## TAWHEED CENTER PARKING LOT EXPANSION JSP24-27

Consideration at the request of Turk Architects for Preliminary Site Plan approval. The subject property, located at 24101 Novi Road, is approximately 1.86 acres in size and is situated west of Novi Road, south of Ten Mile Road (Section 27). The property is zoned OS-1 (Office Service District). The applicant is proposing to add 35 new parking spaces and associated landscaping to the north side of the existing 9,750 square-foot building.

# PLAN REVIEW CENTER REPORT

Revised Preliminary Site Plan

**PARKING ISLANDS SIZES AND DIMENTIONS**  
**1/8" = 1'-0"**

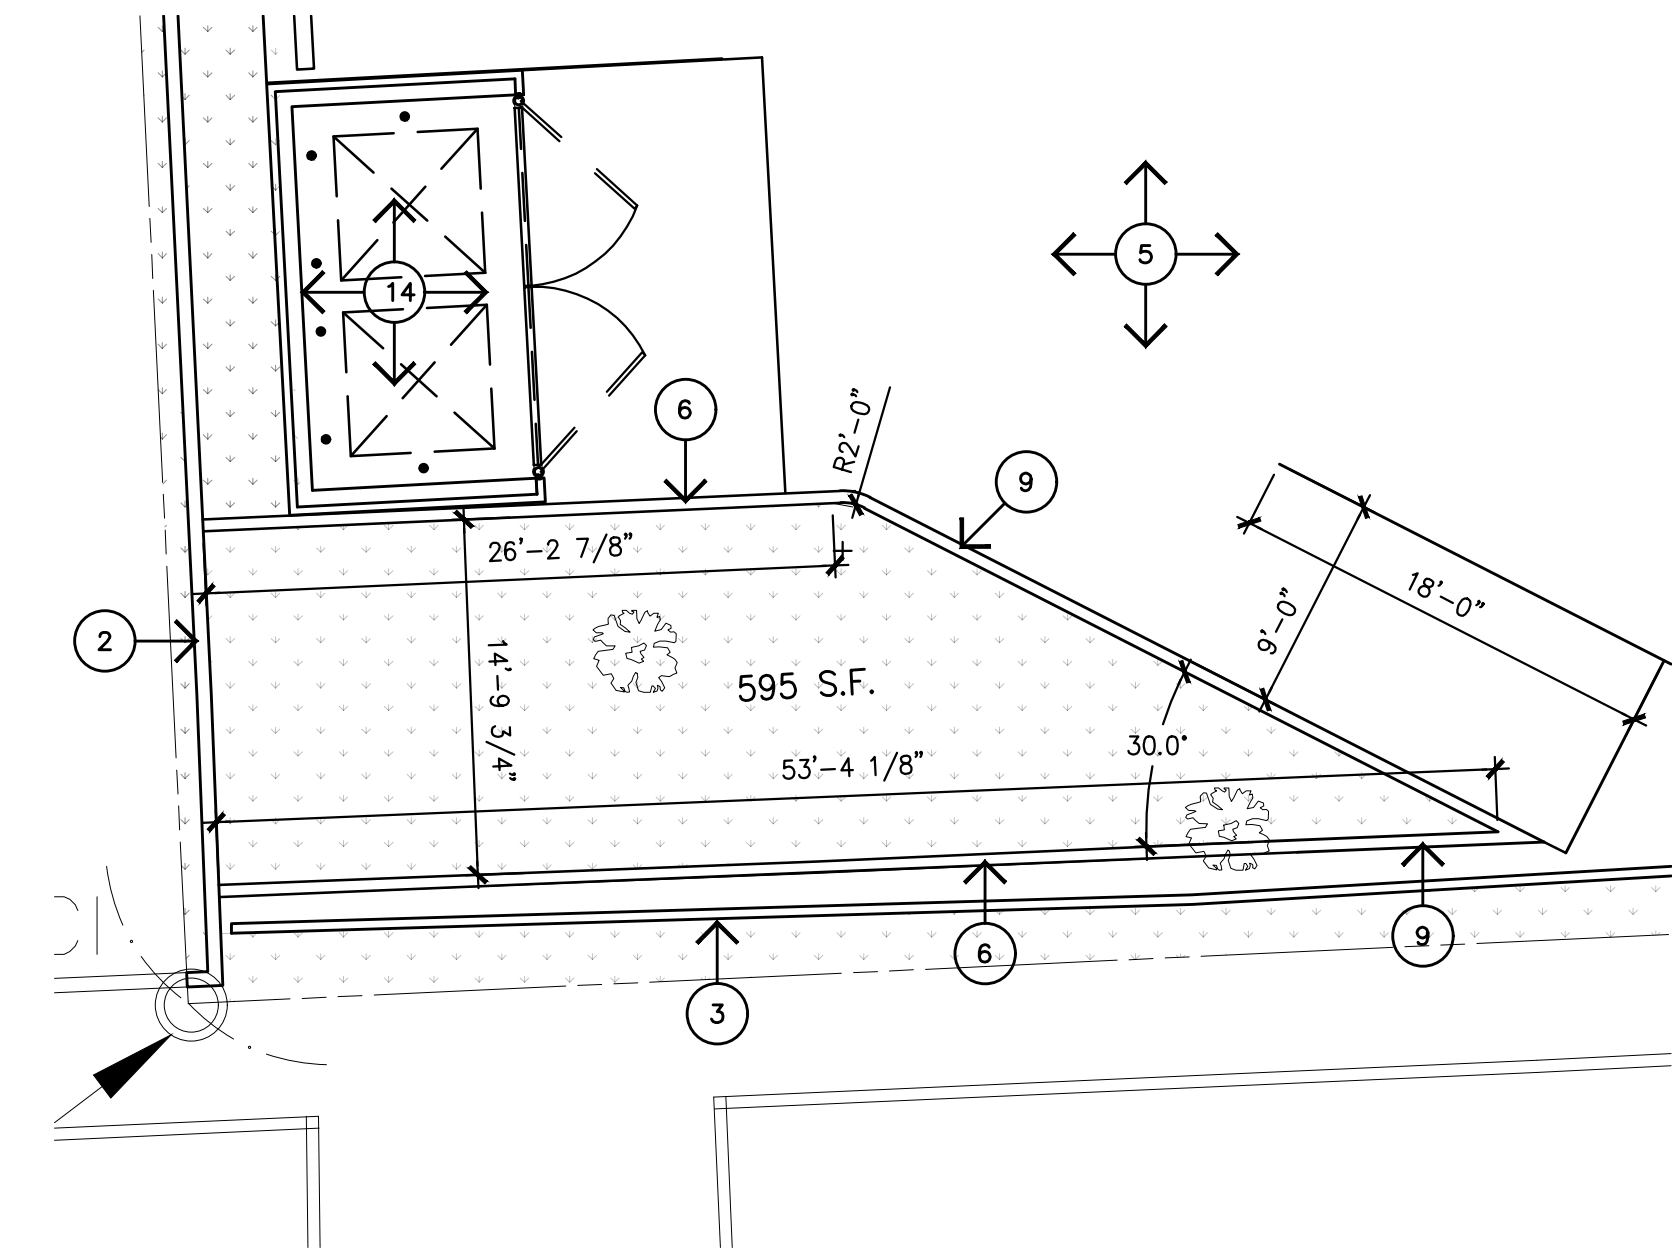
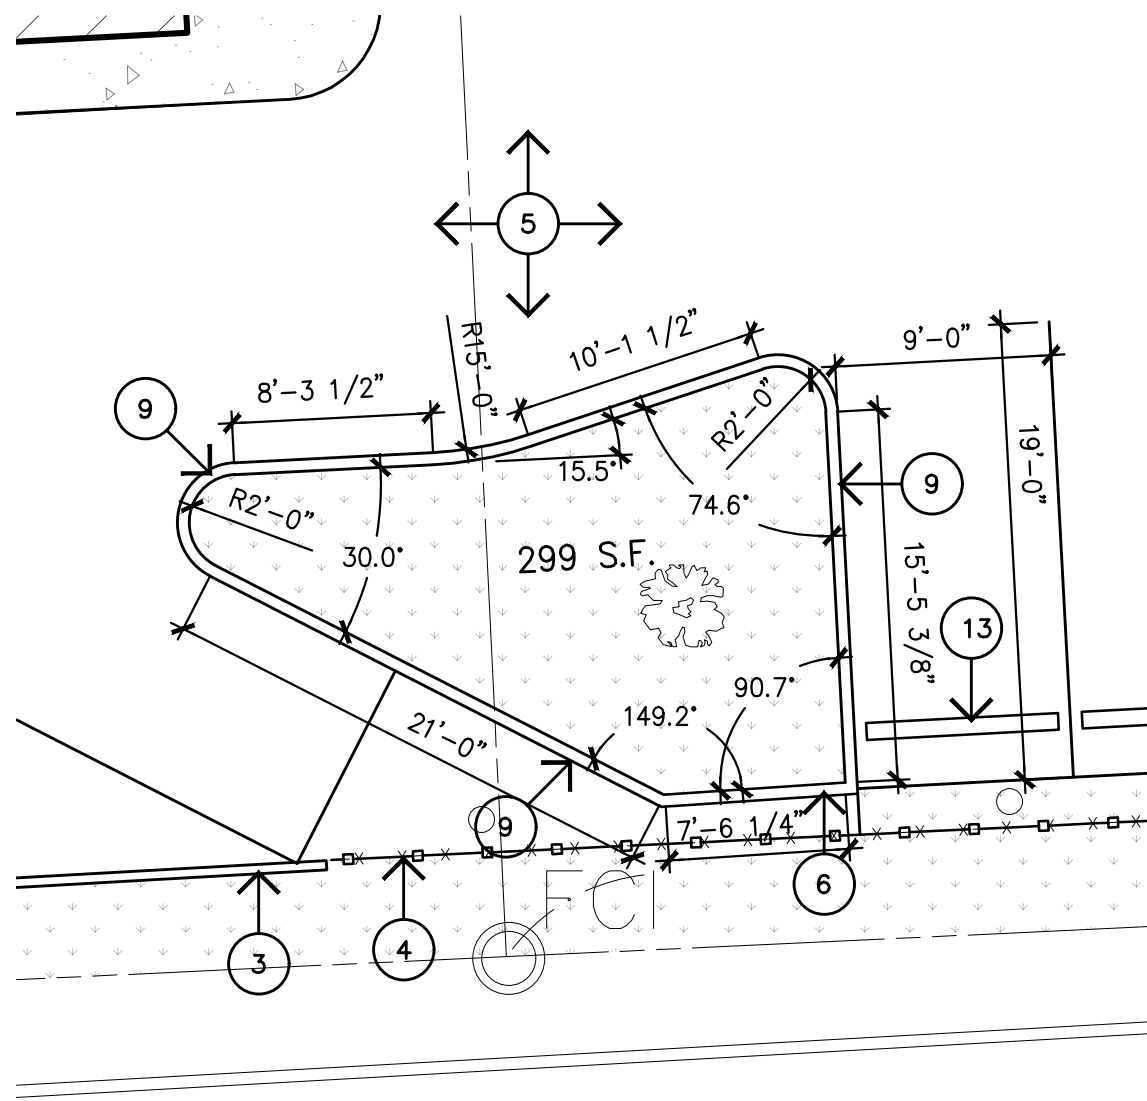
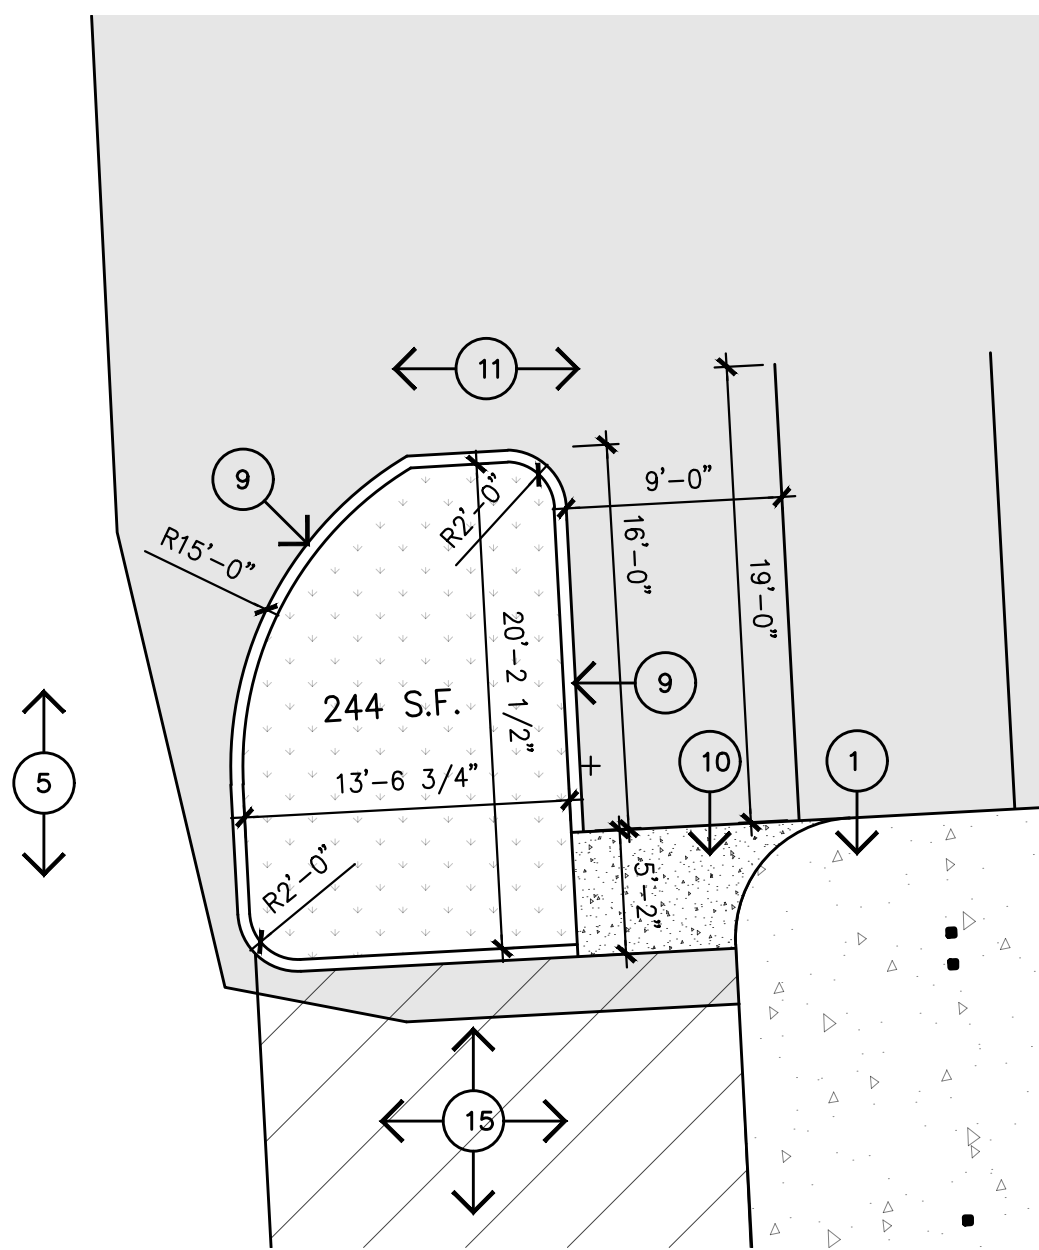
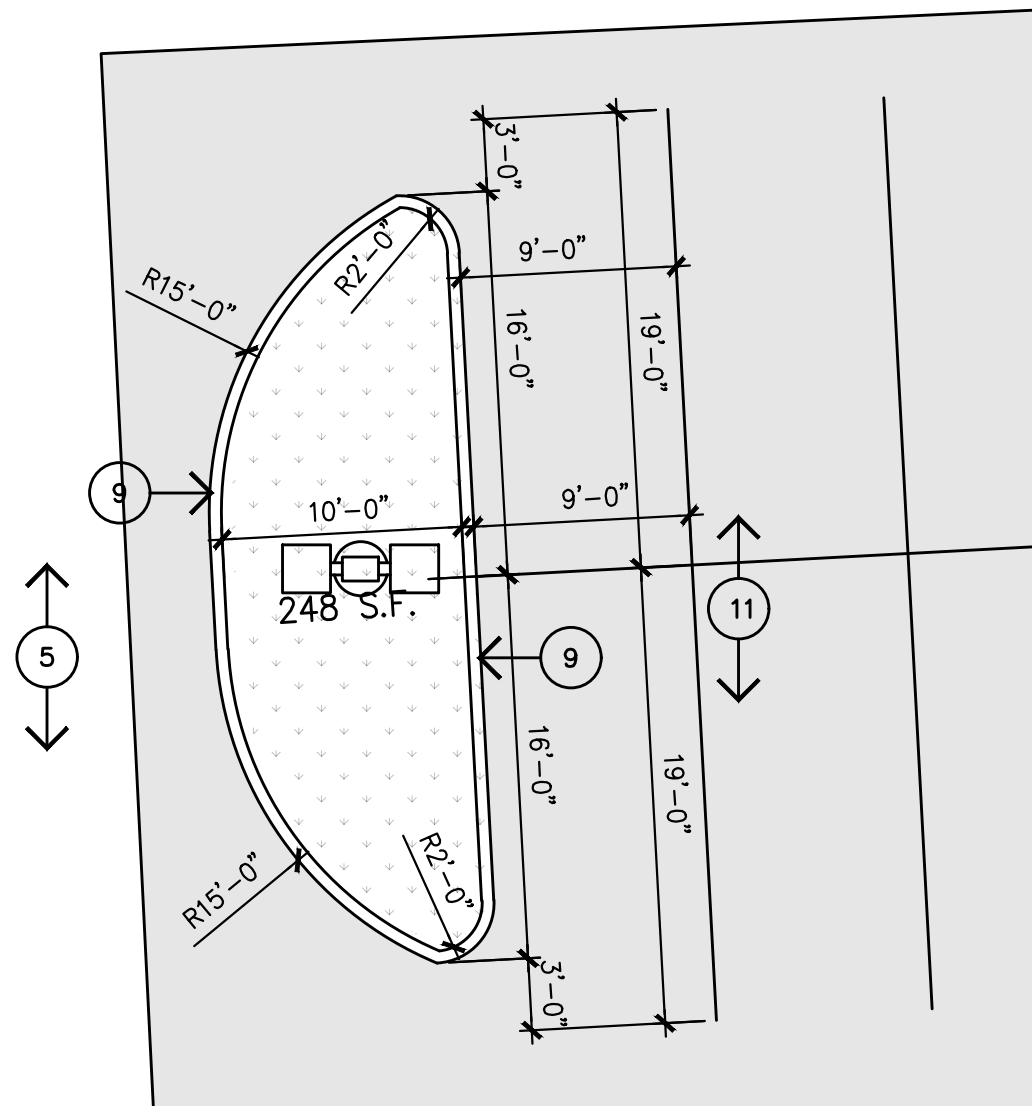
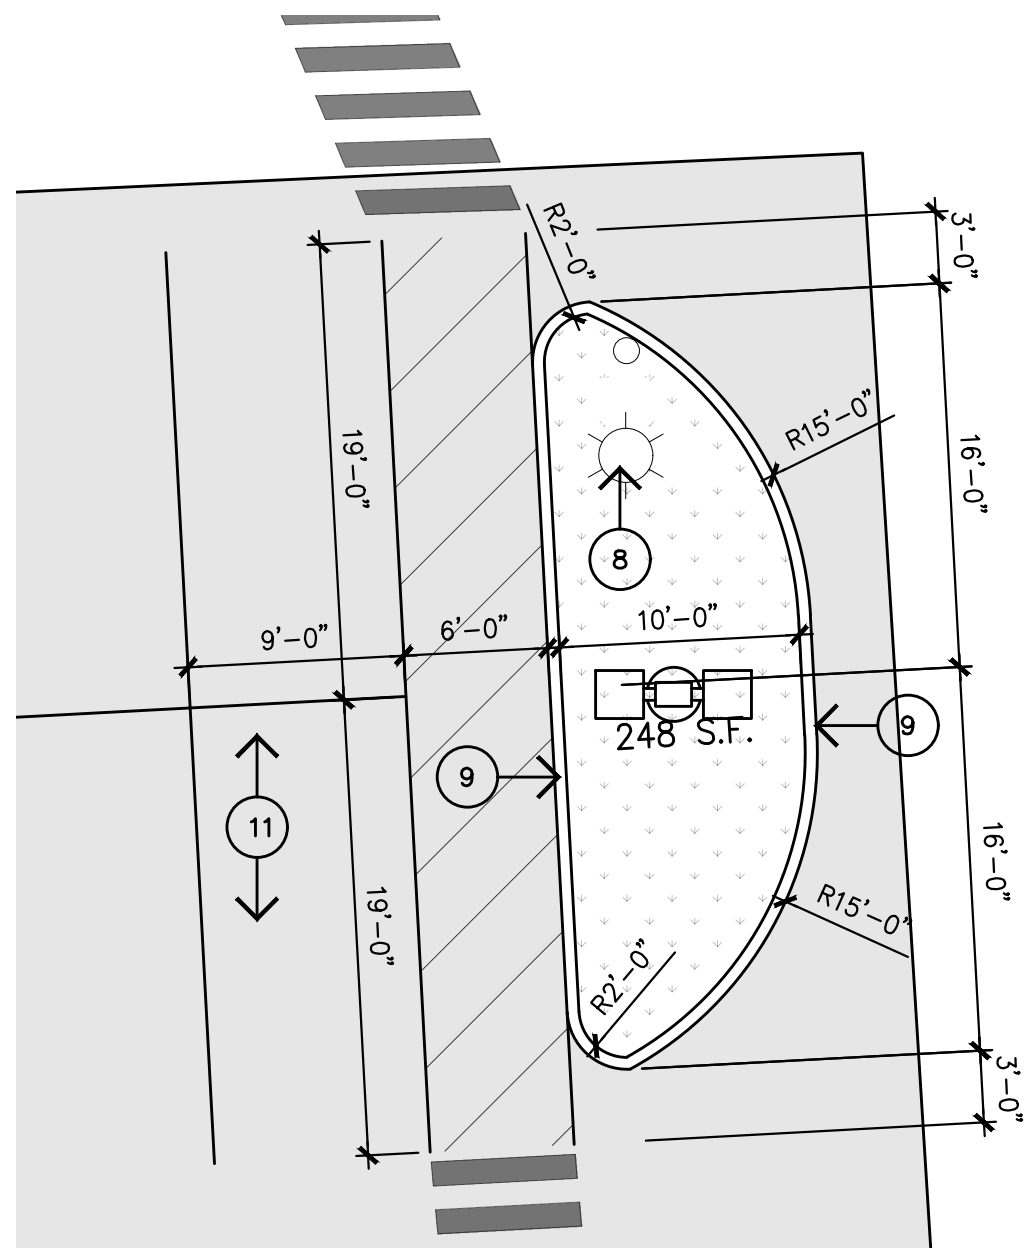
12. The end islands shall conform to the City standard island design, or variations of the standard design, while still conforming to the standards as outlined in Section 5-18 of the [City of Novi Zoning Ordinance - January 8, 2015](#) ( See figure 5.3.12).
